POST TENDER ADDENDUM

JLG 16098 Bottineau Ridge II Apts

RE: post tender addendum 04

Issued: April 3, 2018

SHEET
E301
LARGE SCALE UNIT
PLANS - ELECTRICAL

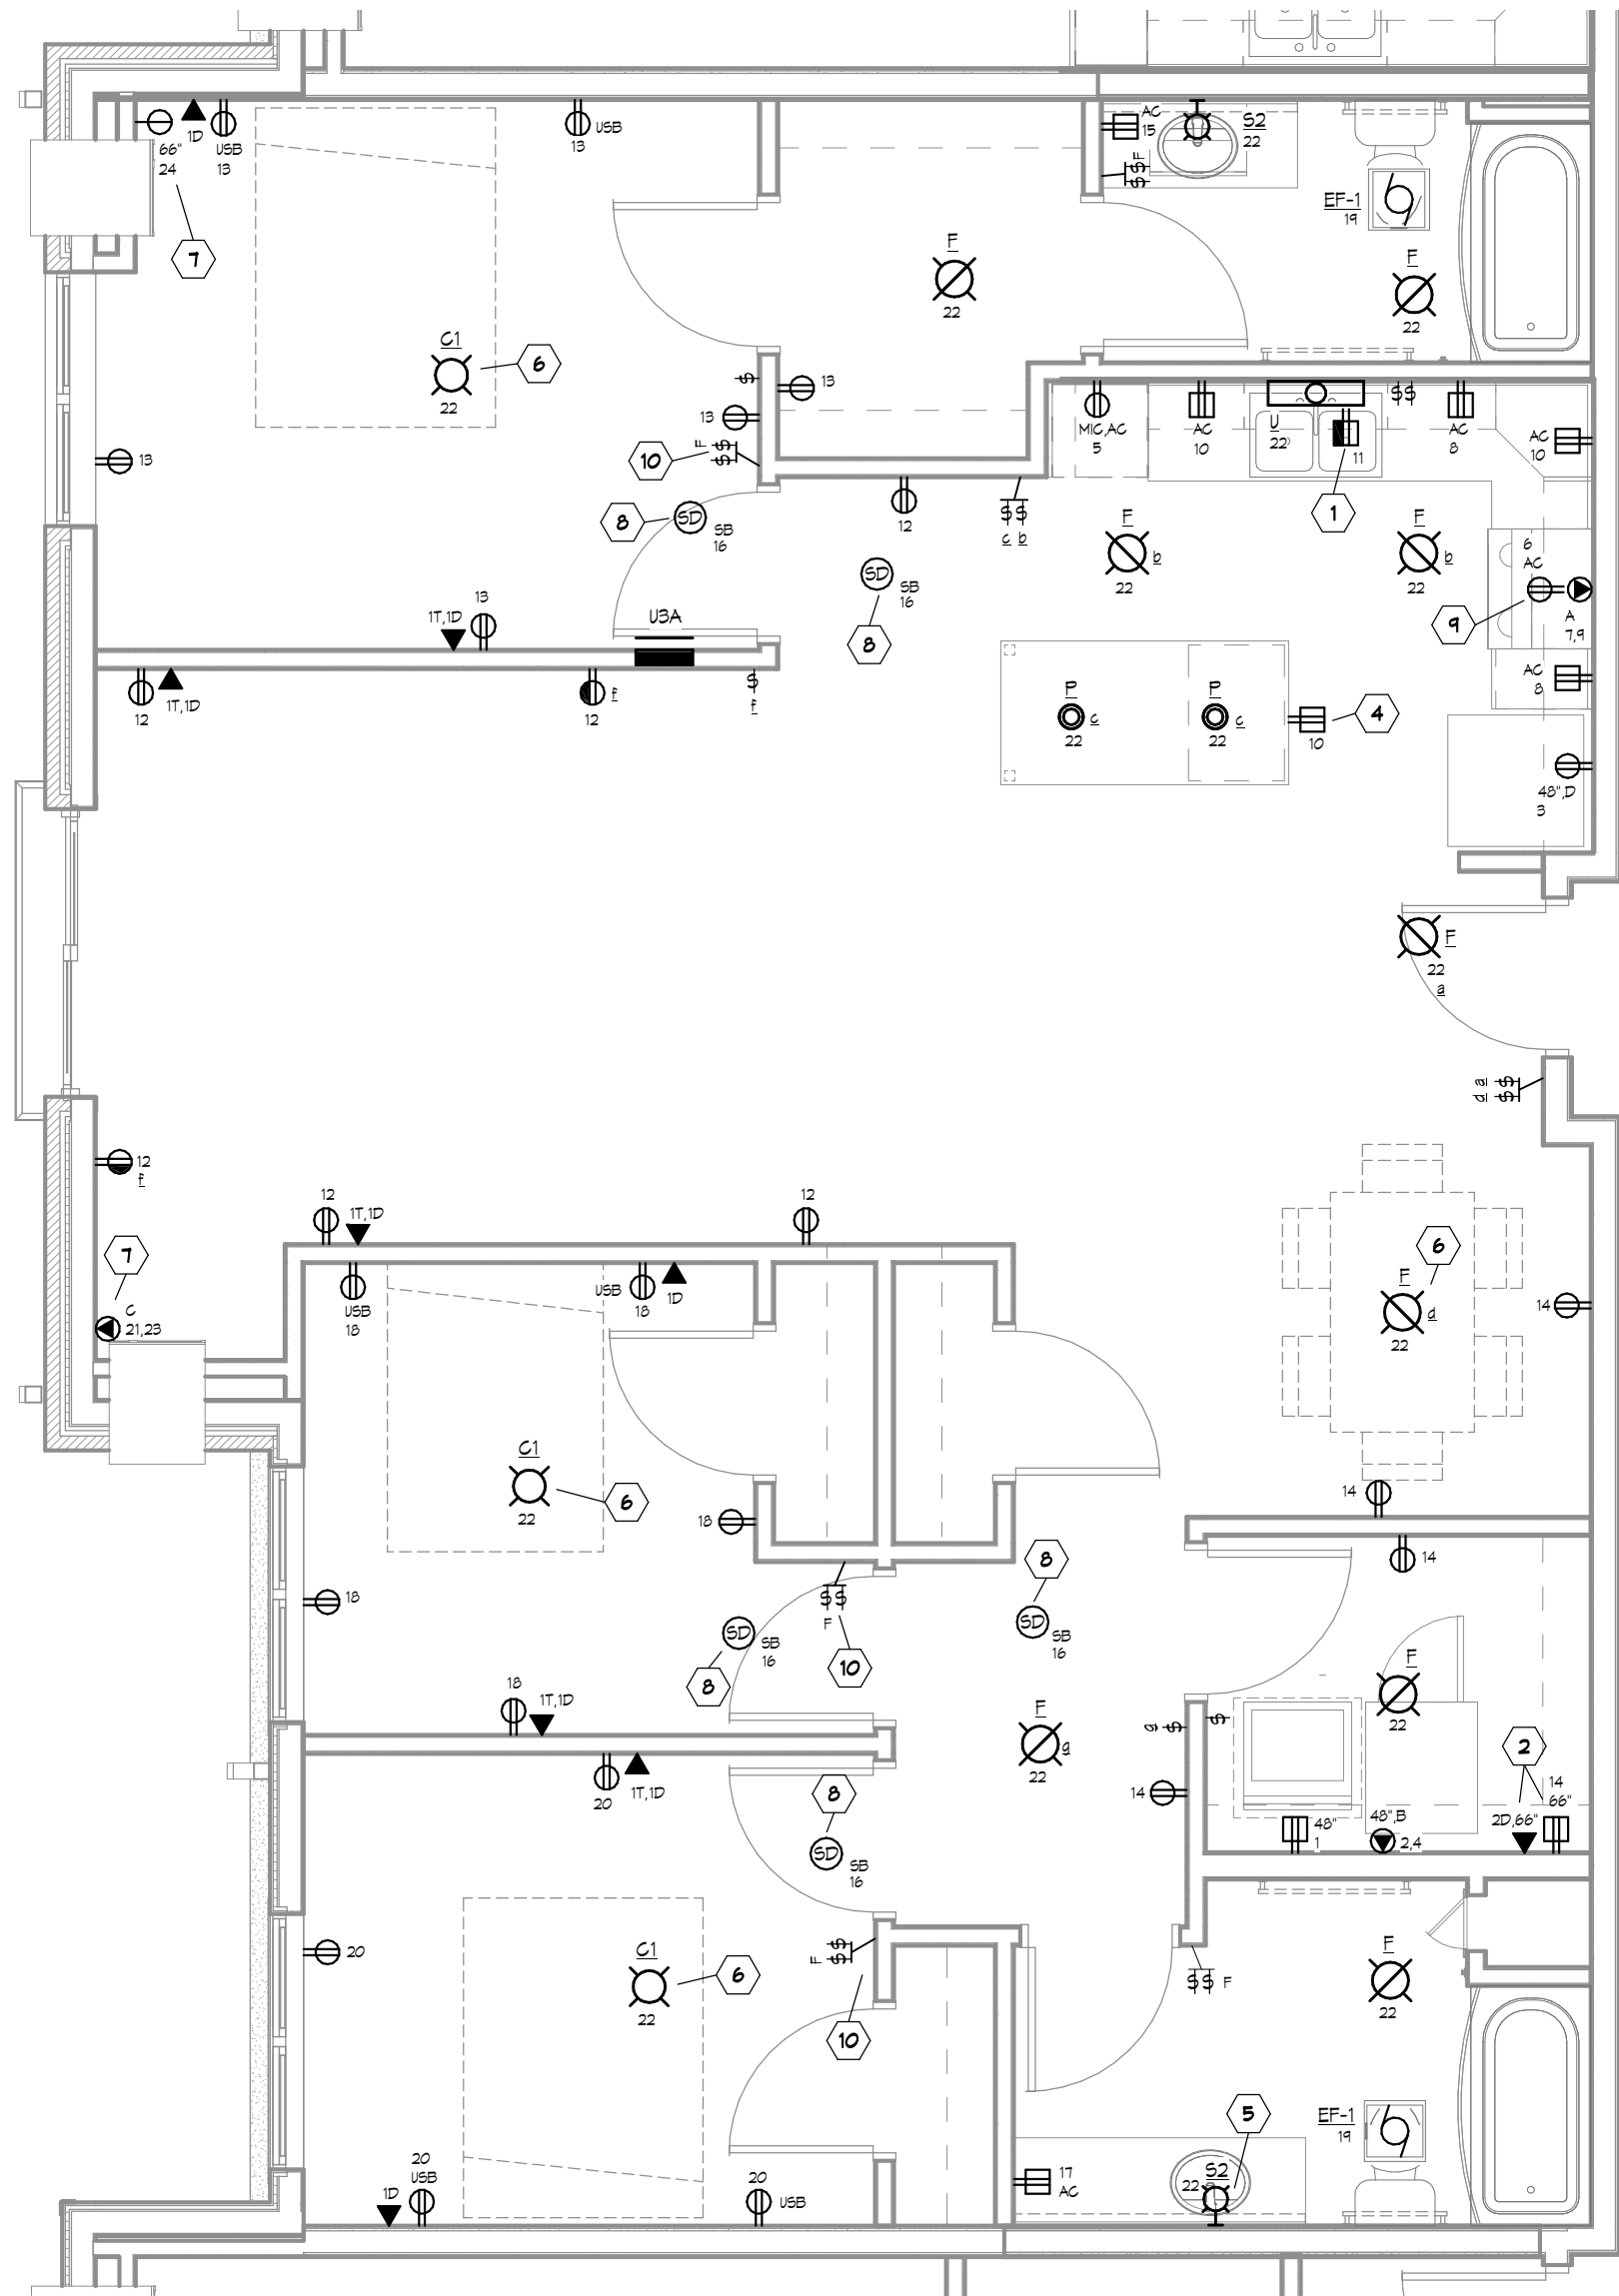
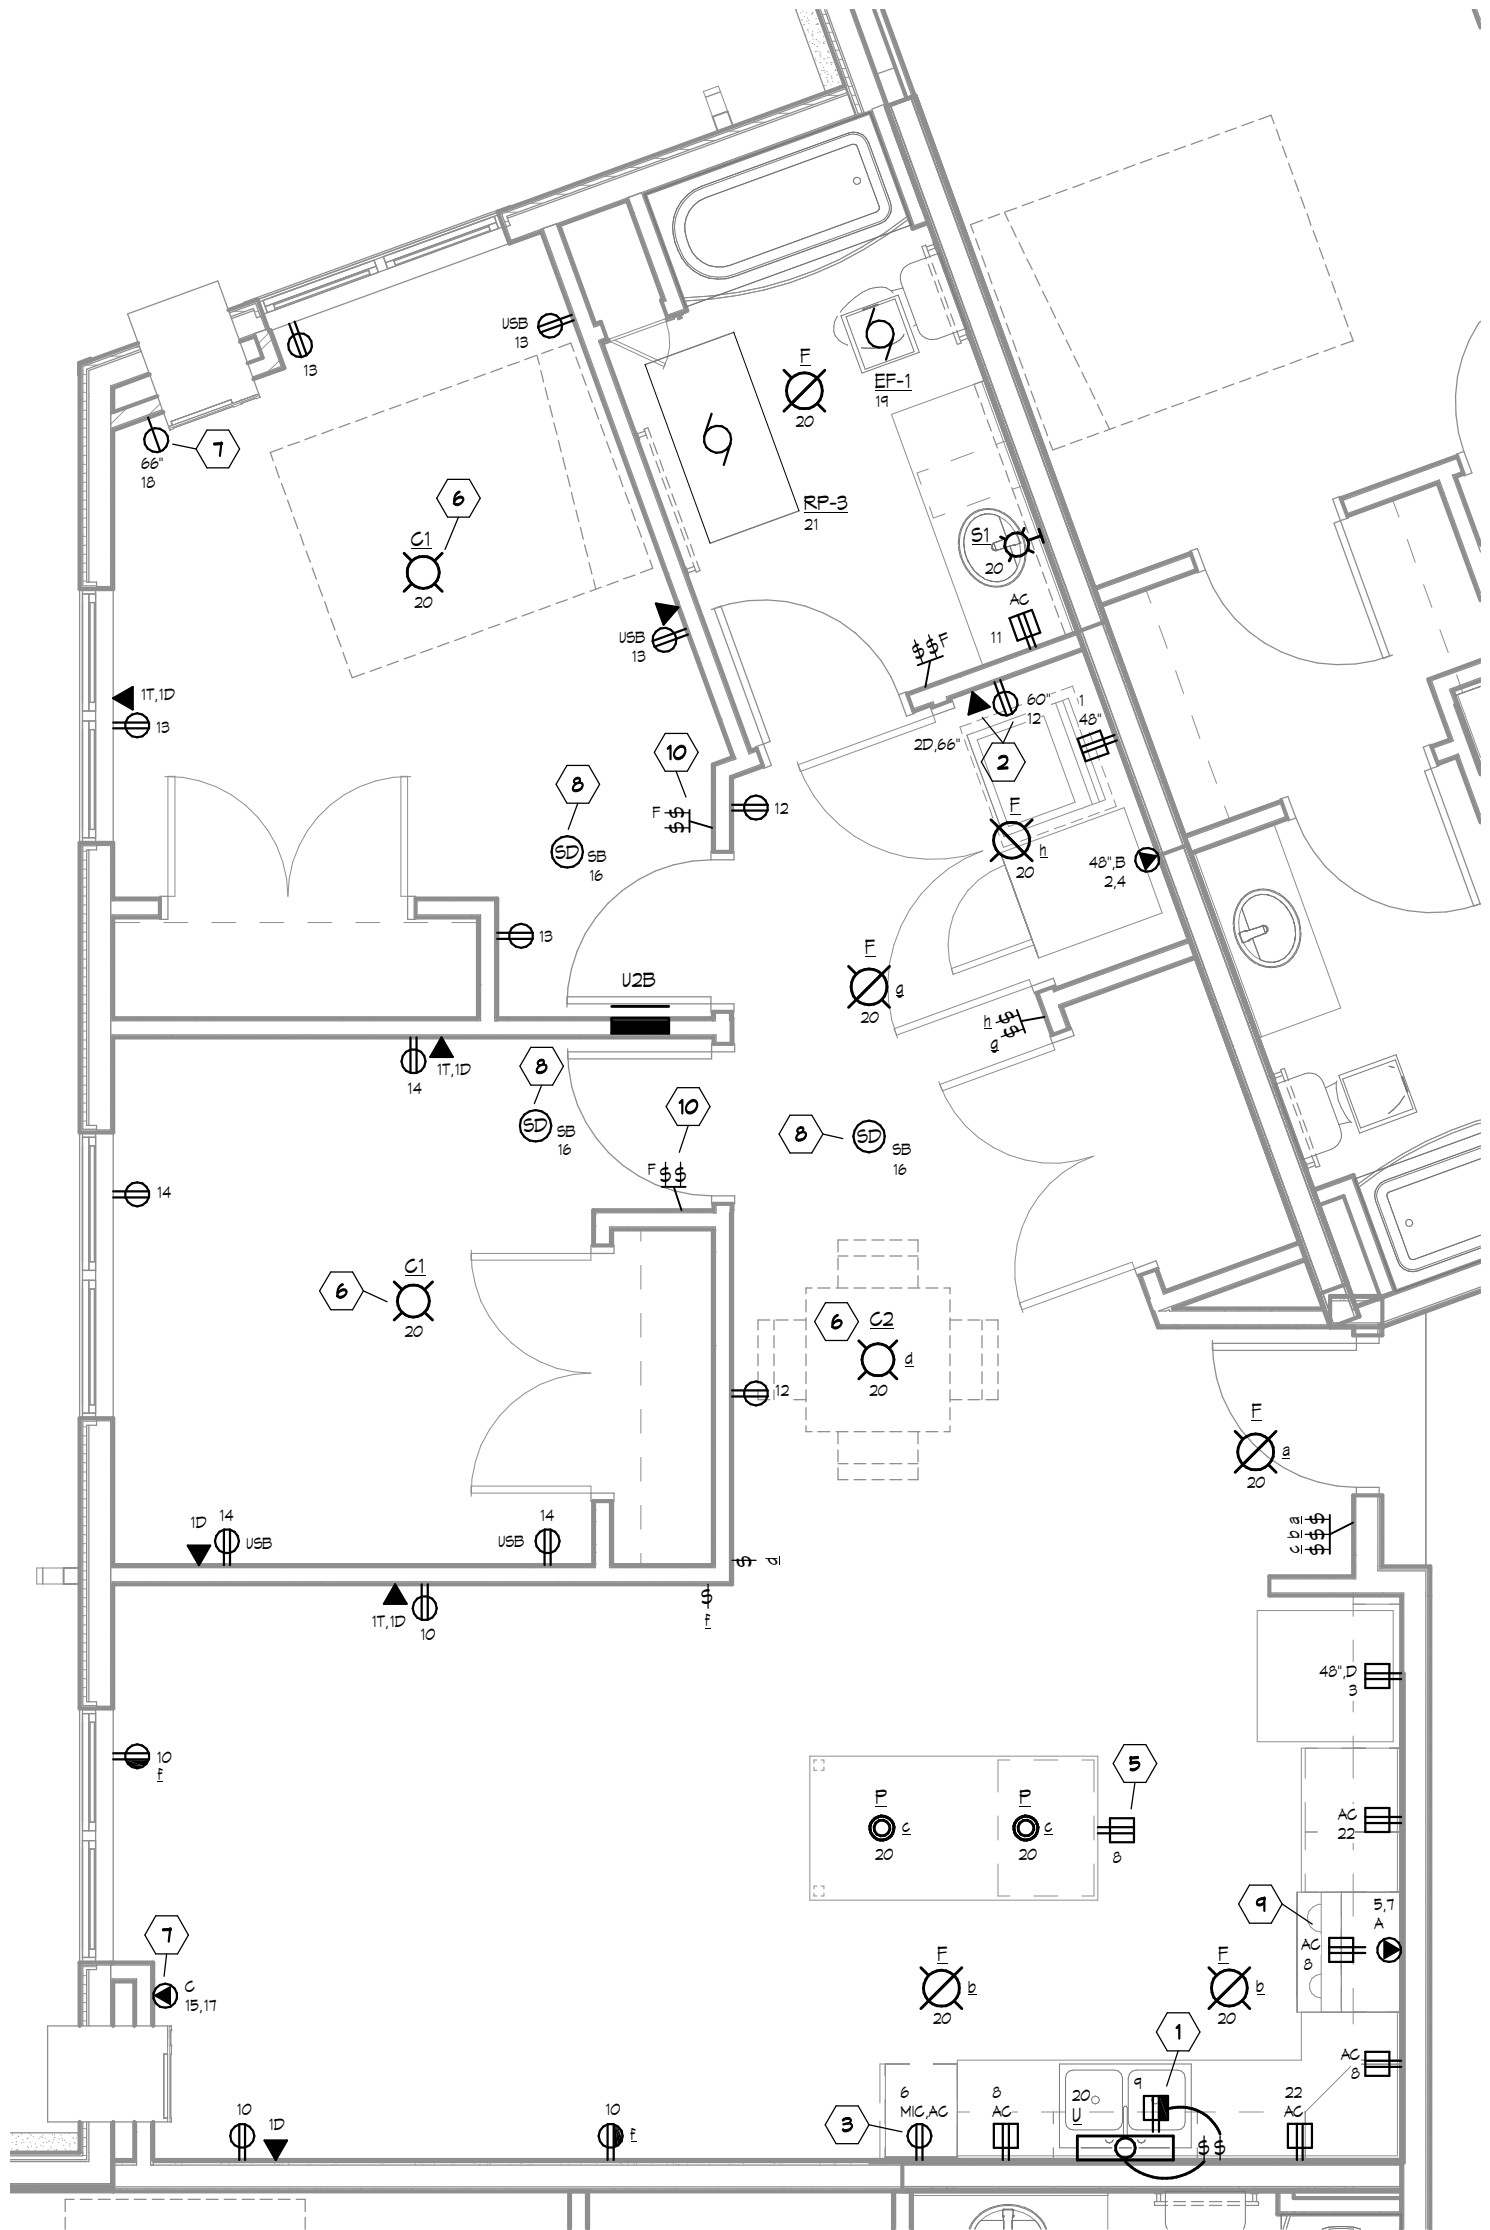
- o 1/4" Unit Elec. Sheet notes, revise note 8."
7. E301 LARGE SCALE UNIT PLANS – ELECTRICAL – See attachment.
 - o 1/4" Unit Elec. Sheet notes, revise note 8."

- SMOKE DETECTORS IN FIRST FLOOR APARTMENT UNITS MONOXIDE/SMOKE DETECTION TYPE. UNDER ALTERNATE 1 MECHANICAL DESIGN. ALL UNITS TO BE COMBINATION CARBON MONOXIDE/SMOKE DETECTION TYPE.

SHEET
E303
LARGE SCALE UNIT
PLANS - ELECTRICAL

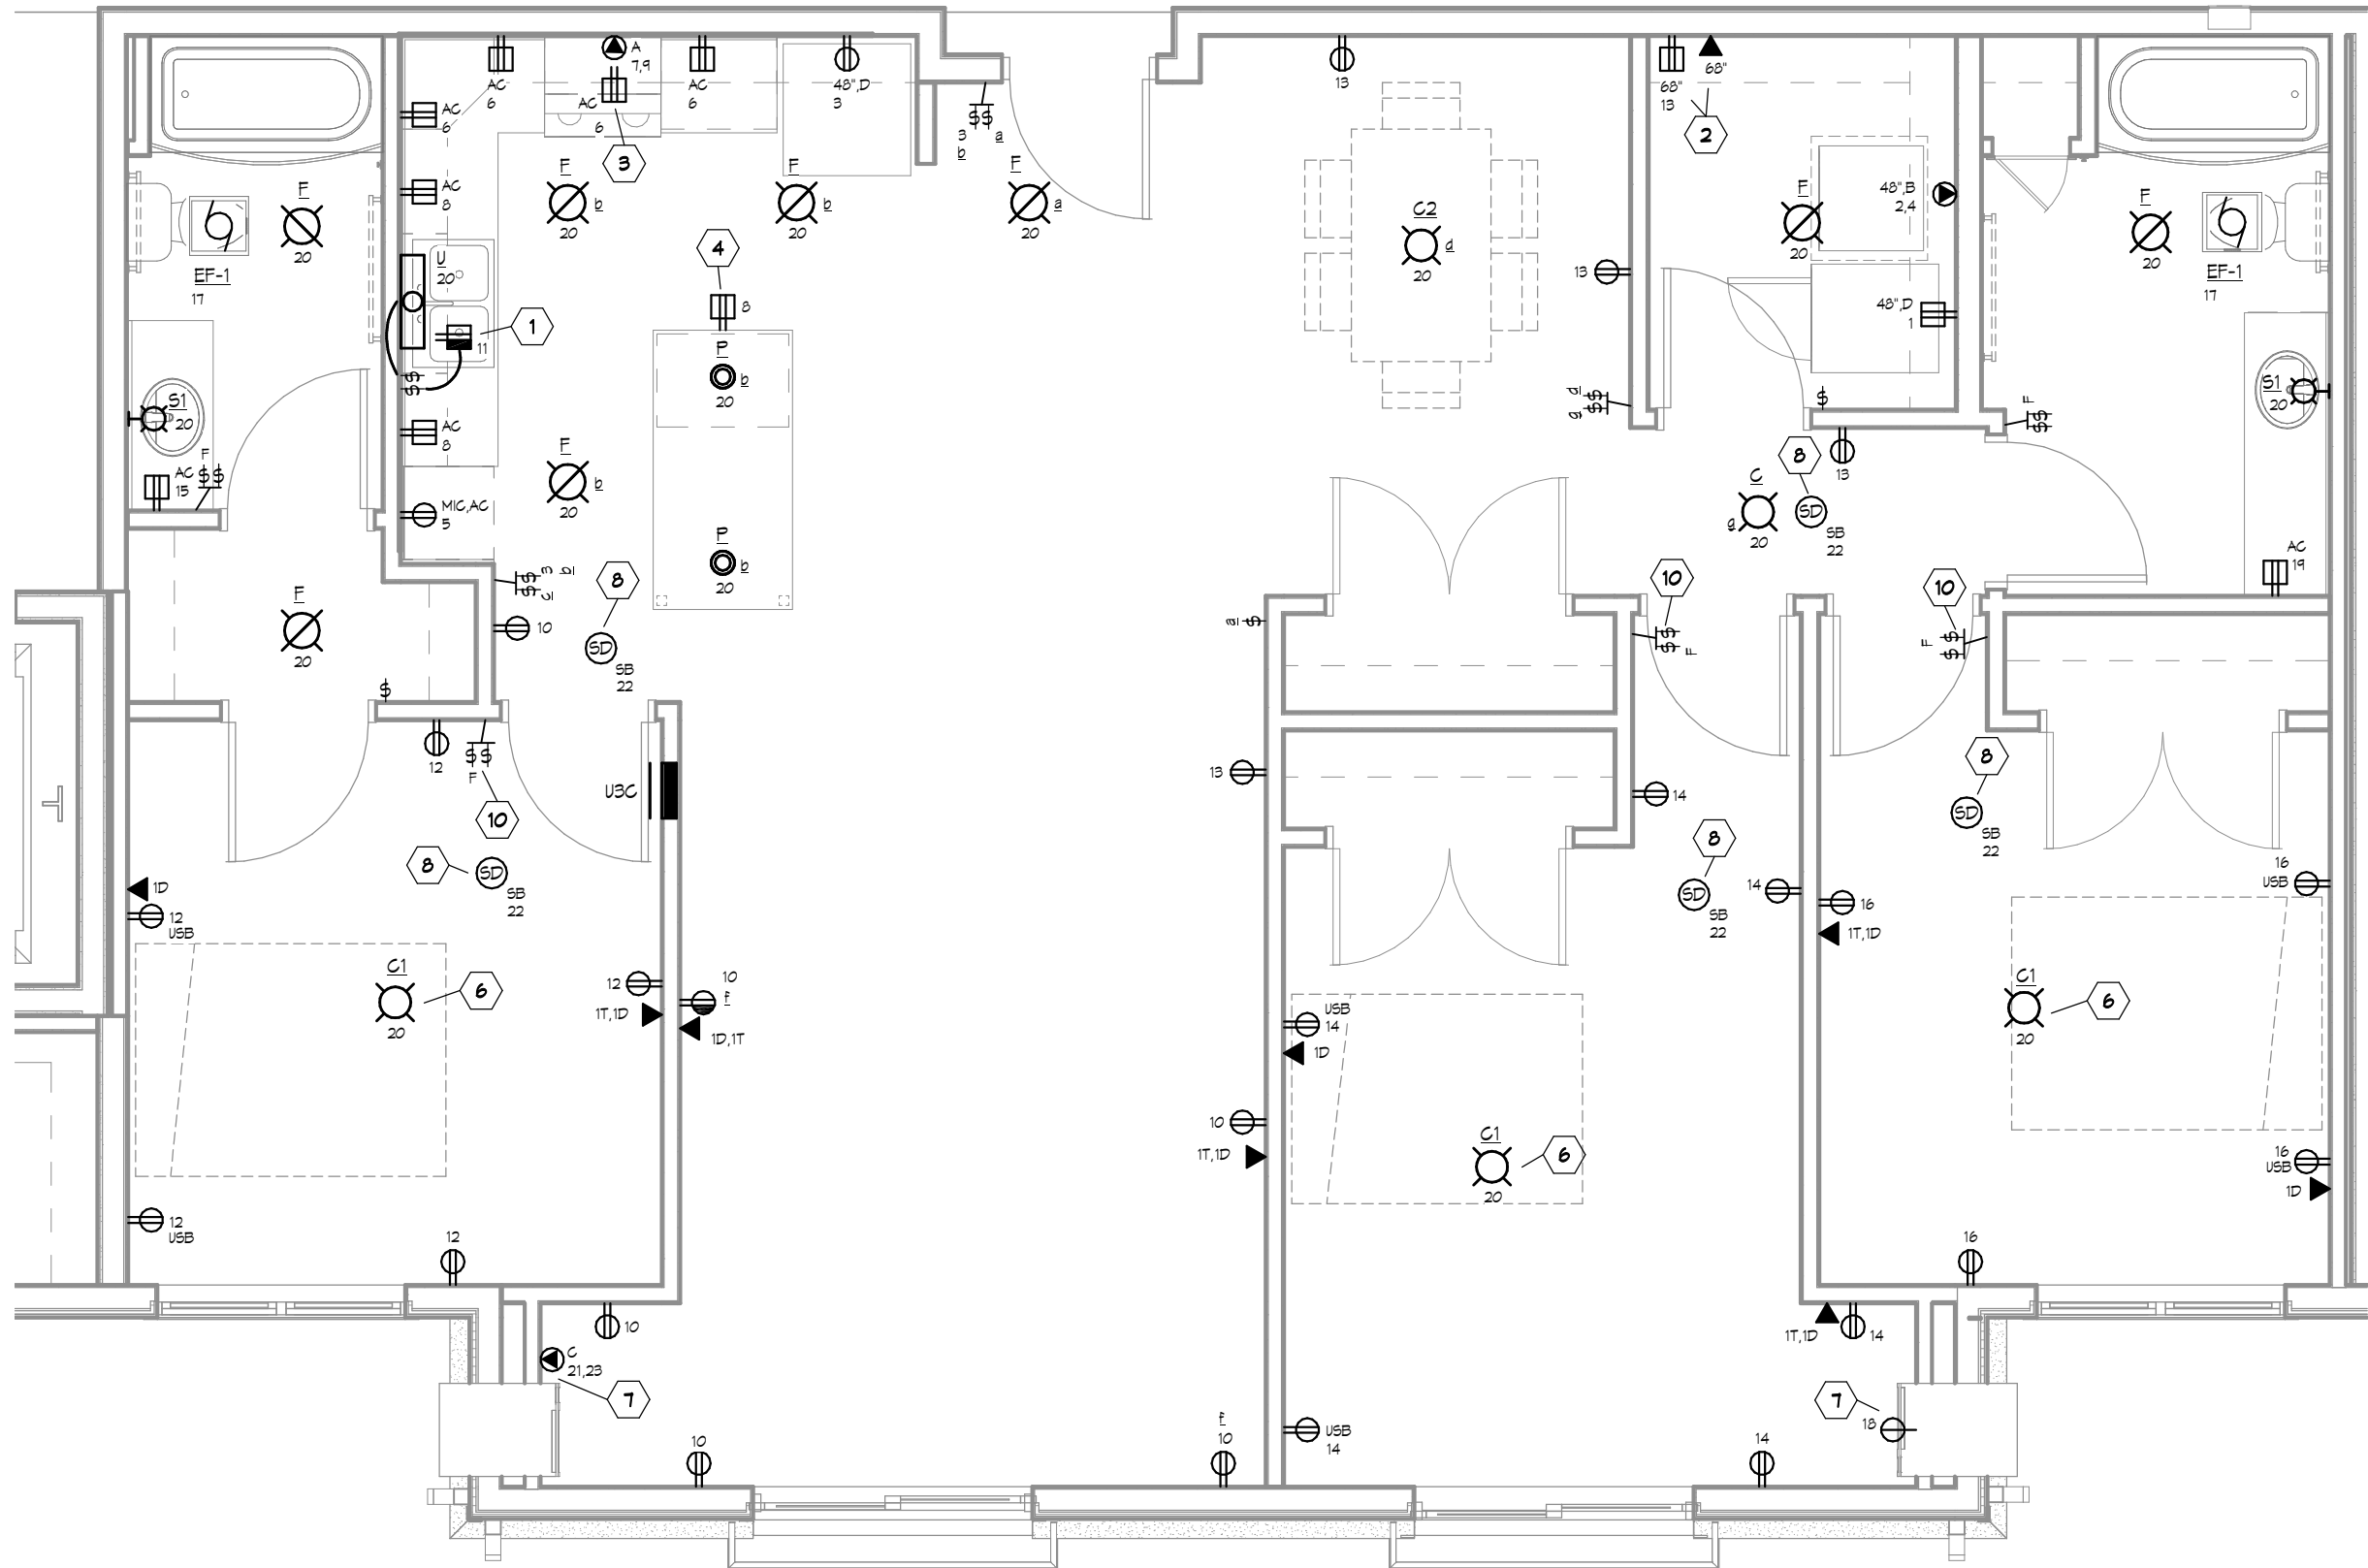
8. E302 LARGE SCALE UNIT PLANS – ELECTRICAL – See attachment.
 - o 1/4" Unit Elec. Sheet notes, revise note 8."
9. E303 LARGE SCALE UNIT PLANS – ELECTRICAL – See attachment.

- o 1/4" Unit Elec. Sheet notes, revise note 8."
